NORTH ANNA POWER STATION, UNIT NO. 2

AMENDMENT TO FACILITY OPERATING LICENSE

Amendment No. 41
License No. NPF-7

AMENDMENT NO. 41 TO FACILITY OPERATING LICENSE NO. NPF-7

FIGURE 2.1-1 REACTOR CORE SAFETY LIMITS FOR THREE LOOP OPERATION, 100% FLOW

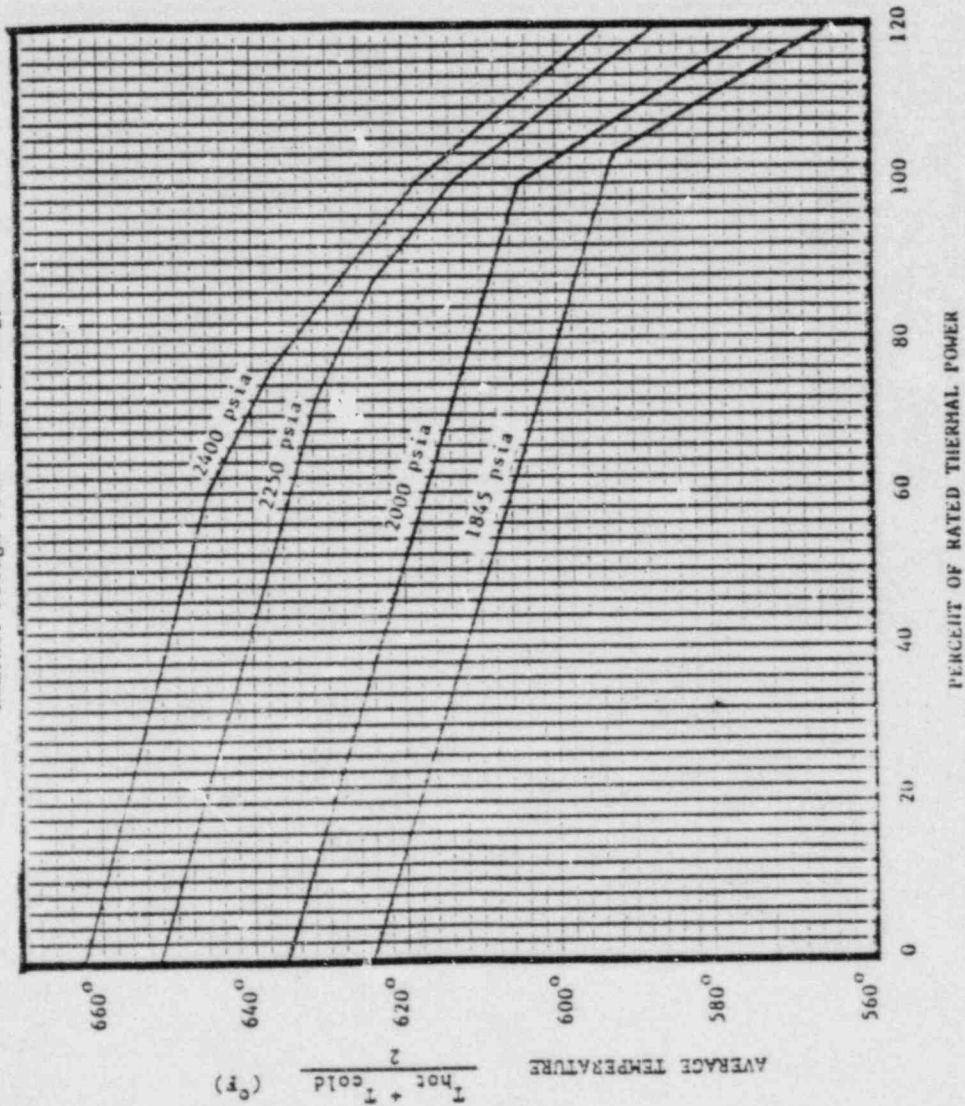
2.1.1 The combination of THERMAL POWER, pressurizer pressure, and the highest operating loop coolant temperature (T_{avg}) shall not exceed the limits shown in Figures 2.1-1 for 3 loop operation and 2.1-2 and 2.1-3 for 2 loop operation.

Nominal Tav_g: 587.8° F
 Nominal Design Flow: 285,000 gpm
